Our reference: MGLA211024-3324

HERITAGE, TOWNSCAPE AND VISUAL IMPACT ADDENDUM: RESPONSE TO GLA CLARIFICATIONS

SPRINGFIELD VILLAGE PH2B

16 AUGUST 2024

VuCity Model Shot 1: Church of St Mary Summerstown and the Lodge (Existing):

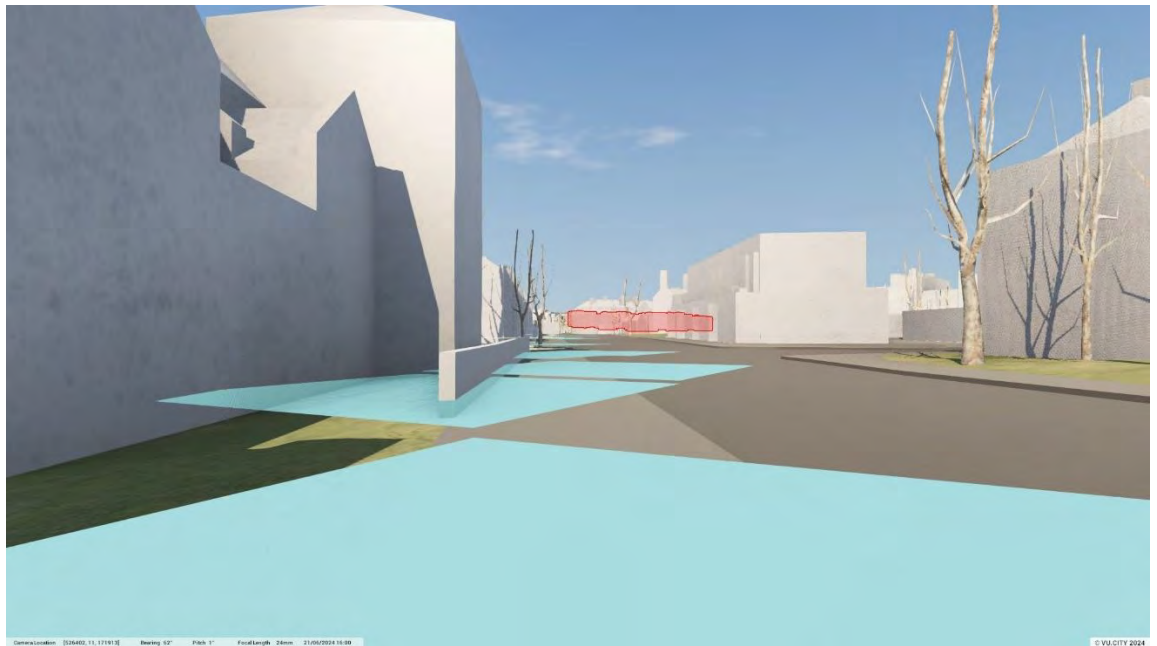
5. *We would like to check the scoping of some heritage assets. The ZTV at page 35 of the current HTVIA suggests that there will be mutual intervisibility between the proposed development and the Church of St Mary, Summers Town and the Lodge, Almshouses and Chapel of St Clements Danes (all to the southwest of the site). I suggest that you provide VuCity model shots from locations within the ZTV area adjacent to these assets and I can then advise whether full AVRs will be needed from these locations.*

The Proposed Development is over 700m from the church. VuCity shows theoretical visibility on the ZTV from Wimbledon Road. The environment in this location is busy with traffic. Between the church and the Site are a number of buildings, a slope in topography and a number of mature trees. A sliver of the Proposed Development is theoretically visible, though in reality, this would not be perceivable at this distance or with the interposing development between the church and the Site.

Magnitude of Impact: Nil; Likely Effect: None. The information to support this conclusion is here:

View 14: From the East of Streatham Cemetery (Existing)

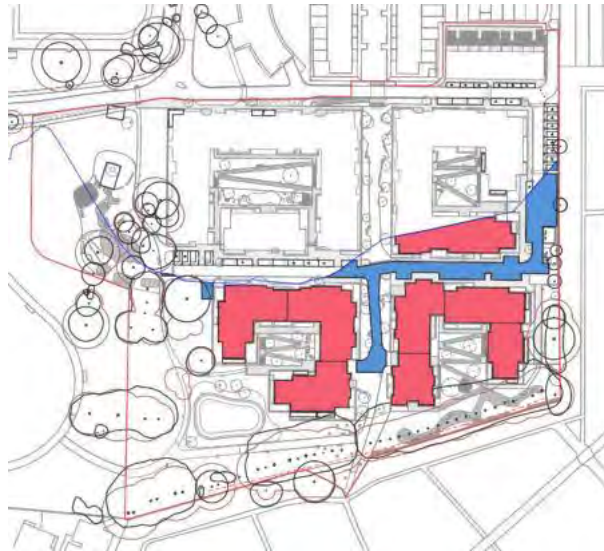
6. Please note the comments of my colleague Charleen Henry, who requested an additional view from the cemetery and a Hi Res version of the existing HTVIA.

The susceptibility to change is Low. The sensitivity is Low/Medium. Using professional judgement, and understanding that the cemetery has distinct, built edge, the sensitivity to change is considered to be Low.

The view shows the Proposed Development in wireline. The blue wireline is representative of the elements of the scheme which are located within the MOL. The green is outside of MOL.

The elements of the south east side of the Site (Block B) are shown in this view. As seen from here, there is a broad edge of MOL within the Site, as the boundary heads northeast to join Streatham Cemetery. The townhouses would be screened by foliage, as would the taller elements to the north of the Site (Block D), which are not within the MOL.
